Access Compliance Report

Public Rights-of-Way

Intersection ID: 17247	Main Street: RANDOLPH_RD	Cross Street: S_CANTERBURY_RD	Location: S
ADA ID: 4F151A28C4B1	Ramp Type: PerpDiag	Initial Pass/Fail: Fail	Overall Compliance: No
		Severity Score: 22.5

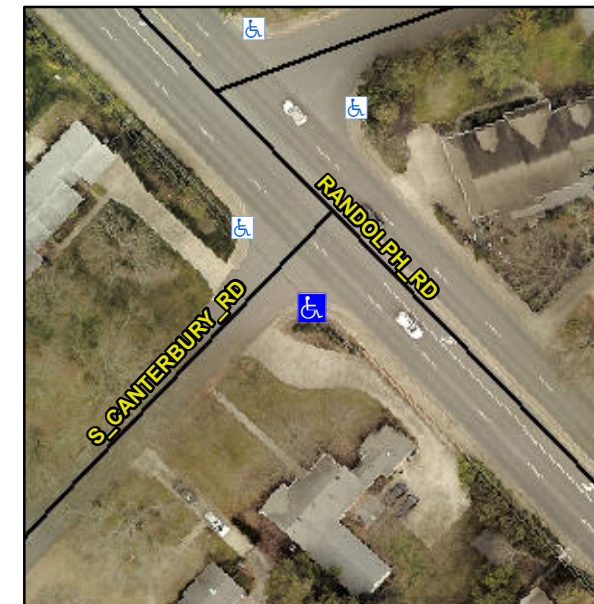
R304.5.1, R304.2.2, R304.5.3

Compliance	Description	Data	Compliance	Description	Data
N/A	Ramp Length (in)	49.0	No	Ramp Slope (%)	11.9
No	Ramp Width (in)	46.0	No	Ramp XSlope (%)	2.8
N/A	Flare Type LT	N/A	N/A	Flare Type RT	N/A
N/A	Flare Slope LT (%)	N/A	N/A	Flare Slope RT (%)	N/A
N/A	Flare Traversable LT?	N/A	N/A	Flare Traversable RT?	N/A
N/A	Landing Length (in)	N/A	N/A	DWS Provided?	N/A
N/A	Landing Width (in)	N/A	N/A	DWS Contrast?	N/A
N/A	Landing Slope (%)	N/A	N/A	DWS Length (in)	N/A
N/A	Landing X Slope (%)	N/A	N/A	DWS Full Width?	N/A
N/A	Landing Curb? (Y/N)	N/A	N/A	DWS Offset (in)	N/A
N/A	Shared Landing?	N/A			
N/A	Gutter Ponding?	N/A	N/A	Gutter Slope (%)	N/A
N/A	Gutter Lip Ht (in)	N/A	N/A	Gutter X Slope (%)	N/A
N/A	Painted X Walk1?	No	N/A	Painted X Walk2?	No
	X Walk 1 Direction	To NE		X Walk 2 Direction	To NW
N/A	X Walk 1 Width (in)	N/A	N/A	X Walk 2 Width (in)	N/A
	X Walk 1 Slope (%)	0.7		X Walk 2 Slope (%)	2.4
	X Walk 1 X Slope (%)	2.6		X Walk 2 X Slope (%)	1.7

Remove & Replace Curb Ramp With Two New Directional Ramps or Equivalent.
